# **HP 9133/9134 D/H/L Service Manual**

**Manual part number: 5957-6560**

## SERVICE NOTE

Required Screws in Exchange Flexible

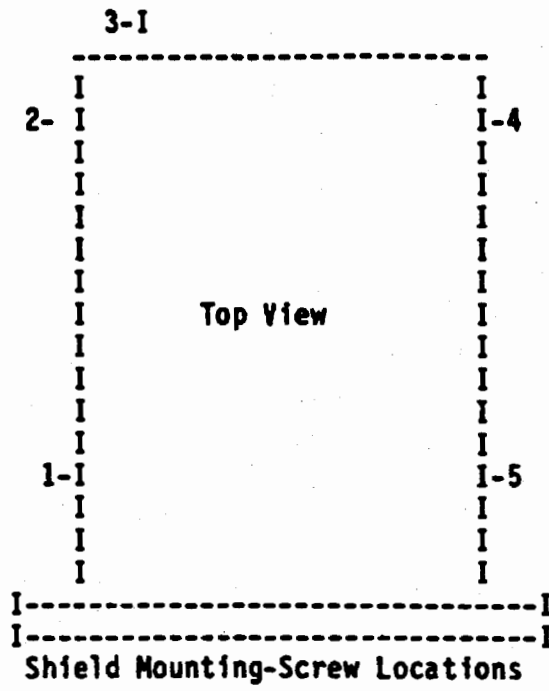
The 09114-69511 Flexible Disc drive is currently used in three products; the 9114A, the 9122D/S, and the 9133D. There are 5 possible locations for mounting-screws that attach the shield to the frame of the drive. Each product requires a different minimum number of screws. In some cases, screws must NOT be installed in certain locations.

All drives in the 9133D's have been shipped with the proper mounting-screws. However, many of the EXCHANGE drives shipped prior to September 1984 contained only the one rear mounting-screw. The exchange drive is now being shipped with the MAXIMUM number of screws to accommodate all products that use the drive.

The 9133D requires screws in locations 2 and 3 ONLY. Screws 1,4, and 5 MUST BE REMOVED.

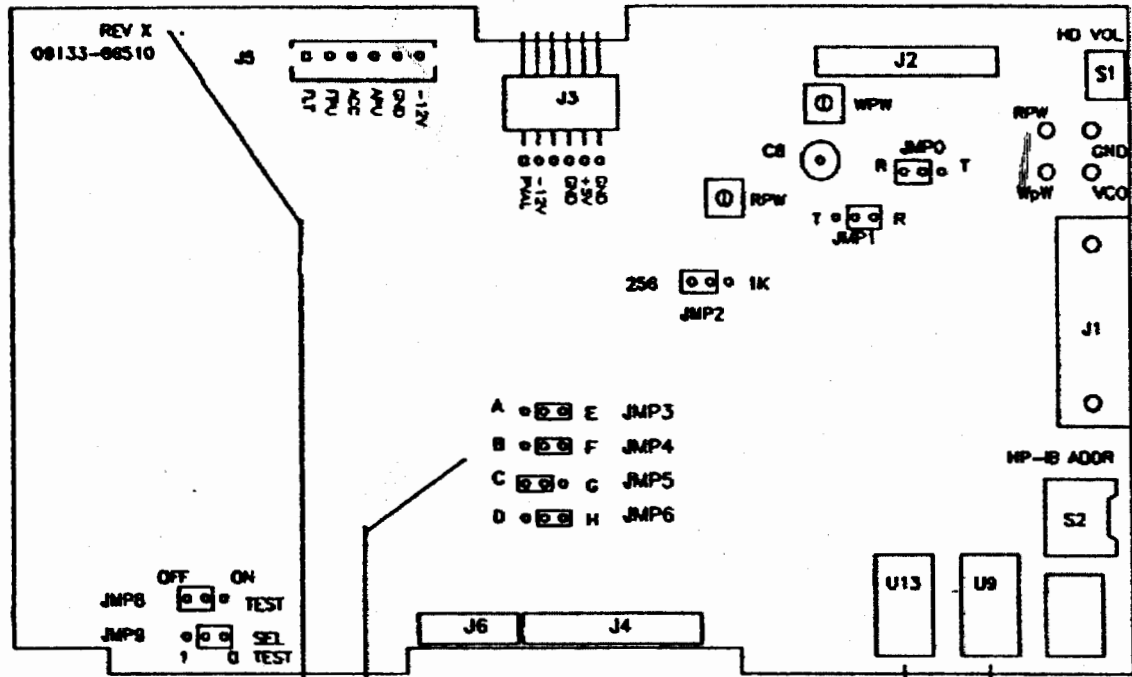
A revised controller PCA is being shipped in all 9133D Disc Drives. The new controller will be in 9133D products beginning at approximately serial number 2419A14750. This controller will also be shipped in all 9133D products with serial number prefix of 2511A and above.

The controller assembly has been revised to use a single IC to perform the hard disc controller and ECC functions which were previously performed by two IC's. Additional changes include a change to a different IC for the phase lock loop for the hard disc, and silkscreen changes to correct an error on the original PCA.

Both the Rev B and the Rev C controller assemblies will be used as exchange assembly 09133-69520. All service inventory of the original exchange assembly 09133-69510 must have firmware updated per service note 9133D-4 before being used to service any 9133D Disc Drives with serial number prefix 2511A or above. Firmware should not be updated in 9133D Disc Drives which are repaired.

Jumpers JMP3-JMP6 must be installed as shown in the figure on the next page to assure correct operation. Note that the jumper configurations shown here differ from those shown in the service documentation for the 9133D.

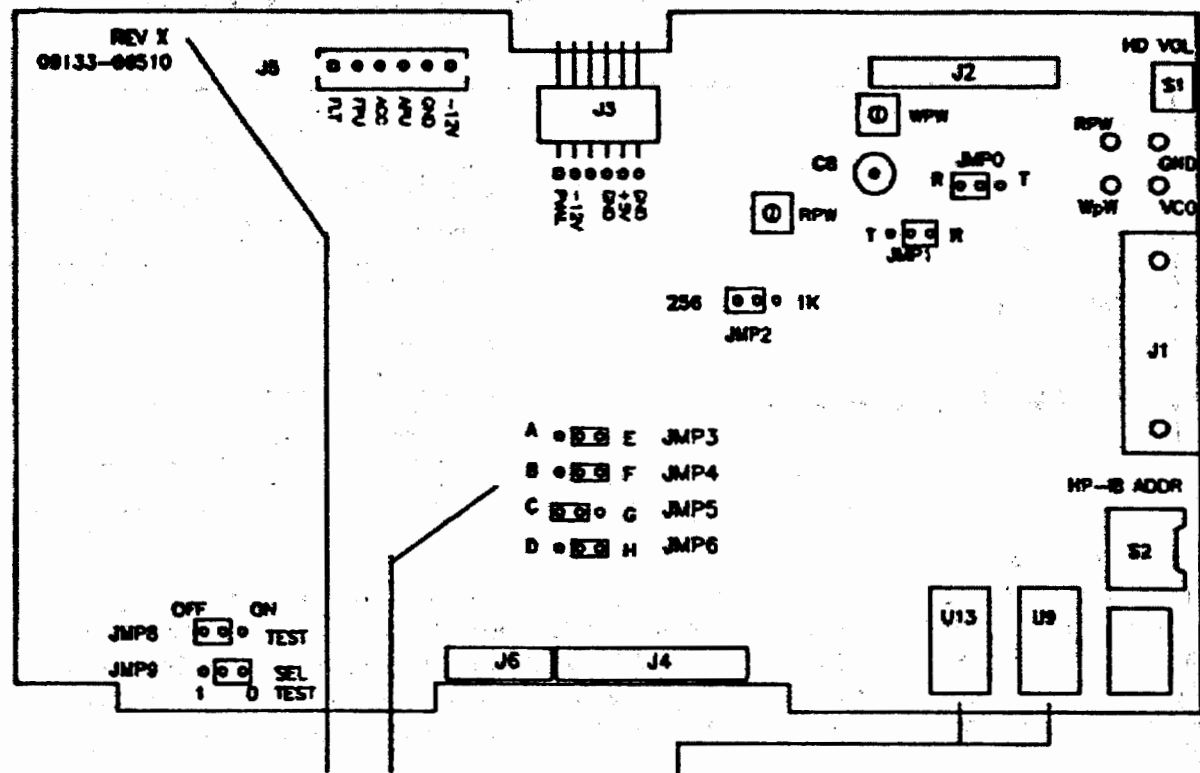
The 09133-69520 Controller PCA which is used in the 9133D, 9133H, 9134D, and 9134H may be a board which has '09133-66510 Rev B' or '09133-66510 Rev C' etched on the board. Jumpers JMP3-JMP6 must be configured properly for the product in which it is installed. Please note that the correct jumper configuration is determined by the product in which it is installed and the revision letter on the PC assembly.

Set JMP3-JMP6 as shown in the figure on the next page to assure that the jumpering is correct for the product in which the controller PCA is installed. Also note that JMP2 will have to be changed when a controller PCA is installed if the disc drive is option 001.

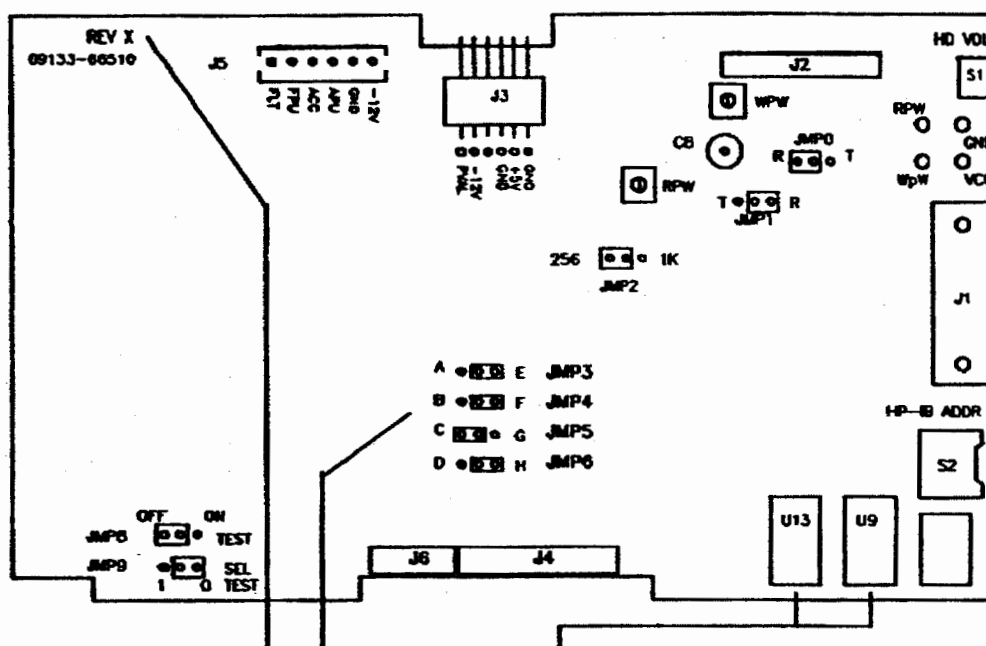
The 09133-69530 Controller PCA which is used in the 9133D, 9133H, 9133L, 9134D, 9134H, and 9134L may be a board which has '09133-66510 Rev B' or '09133-66510 Rev C' etched on the board. The correct configuration of JMP3-JMP6 on the 09133-69530 is determined by the product in which it is installed and the revision letter on the PC assembly.

Set JMP3-JMP6 as shown in the figure on the next page to assure that the jumpering is correct for the product in which the controller PCA is installed.

Note that if the revision letter on a controller PCA which is being replaced is not the same as the revision letter on the controller PCA which is being installed, the jumpering on the two PCA's will not be the same.

Also note that JMP2 will have to be changed when a controller PCA is installed if the disc drive is option 001.
